**Edwin I. Hatch Nuclear Plant
Request to Implement an Alternative Source Term**

AST Safety Assessment

Enclosure 2
Edwin I. Hatch Nuclear Plant
Request to Implement an Alternative Source Term

Description and Justification for Proposed Change

Figure 1. MSIV Alternate Leakage Treatment Pathways

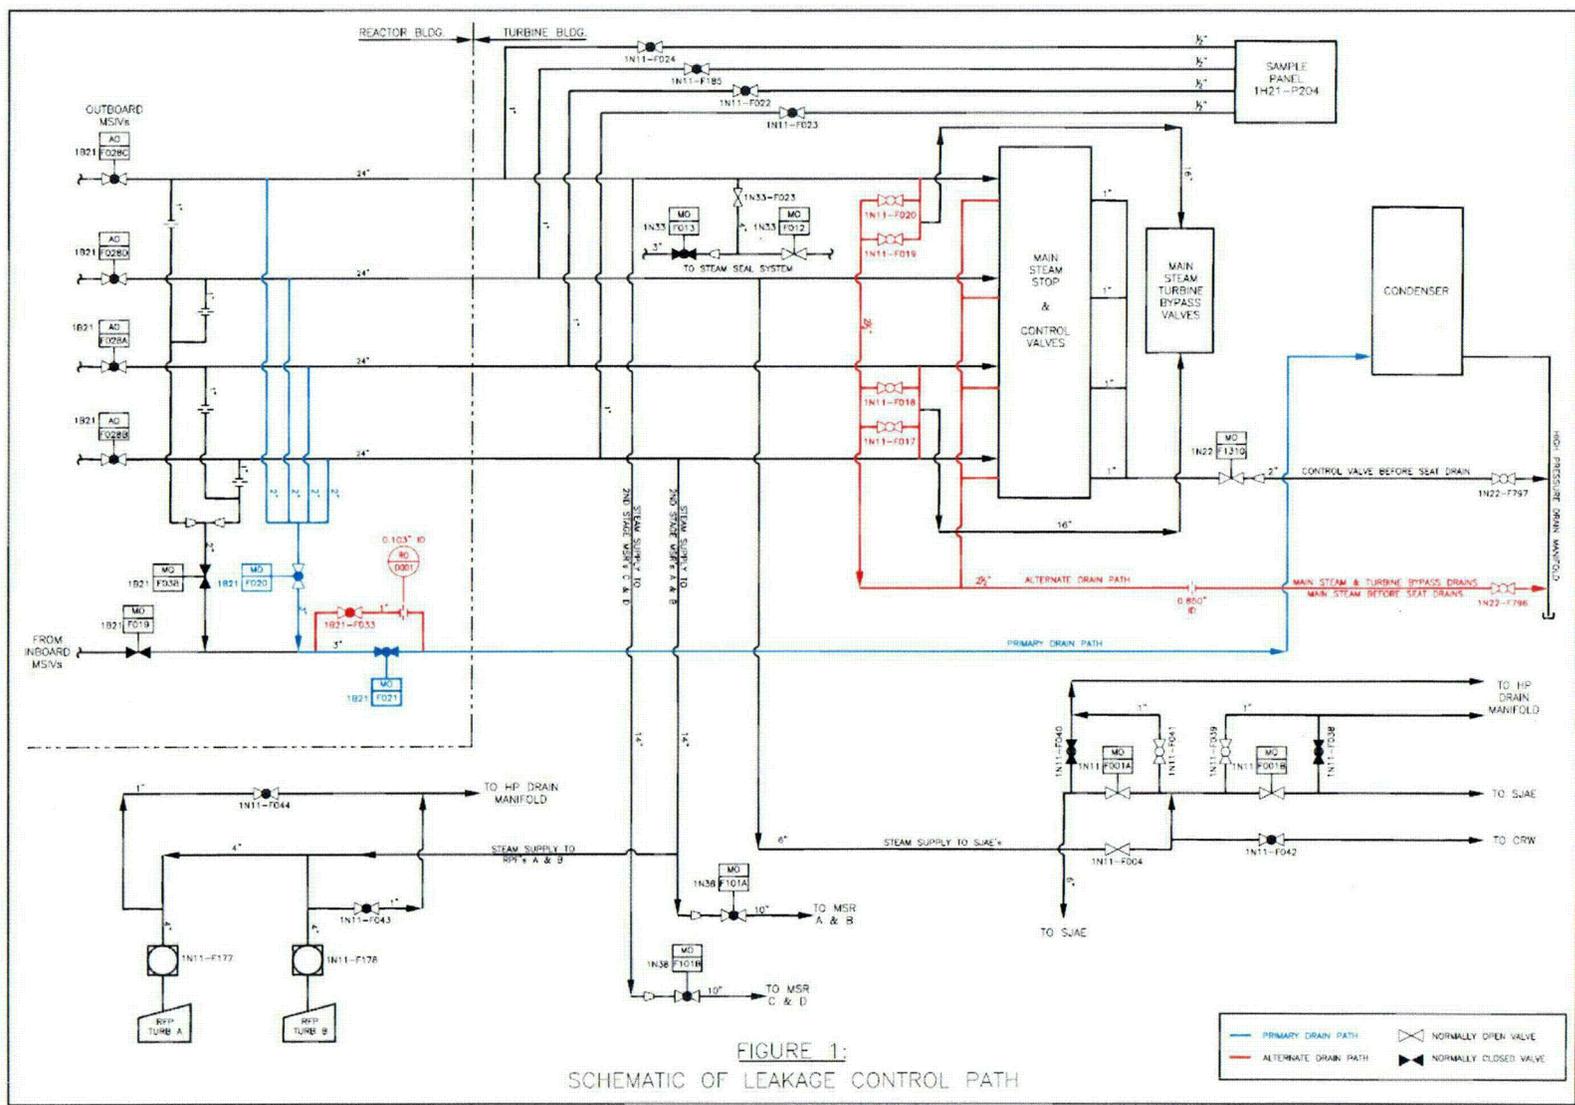
The HNP ALT pathway for Unit 1 utilizes the large volume of the MSLs and the main condenser to provide holdup and plate-out of fission products that may leak through the closed MSIVs. The primary components of the ALT pathway are the main condenser, the MSLs from the MSIVs to the turbine stop and bypass valves, and the drain piping which originates downstream of the outboard MSIVs and terminates at the main condenser. The condenser forms the ultimate boundary of the ALT pathway. Existing valves upstream of the condenser are used to establish the flow path and isolate the boundaries of the path and to limit the extent of seismic verification walkdown. The model for evaluating reduction of MSIV leakage is provided in Reference 3. Figure 1 shows a schematic of the primary and secondary ALT pathways.

All of the piping is located in the TB, primarily in the condenser bay below the operating floor. All of the identified piping provides a direct flowpath to the main condenser for secondary containment bypass leakage from containment. The piping does not have any branch lines. Therefore, there are no boundary components or isolation valves requiring seismic verification. Also, the piping does not contain any valves that must be positioned in order to provide a flowpath to the main condenser.
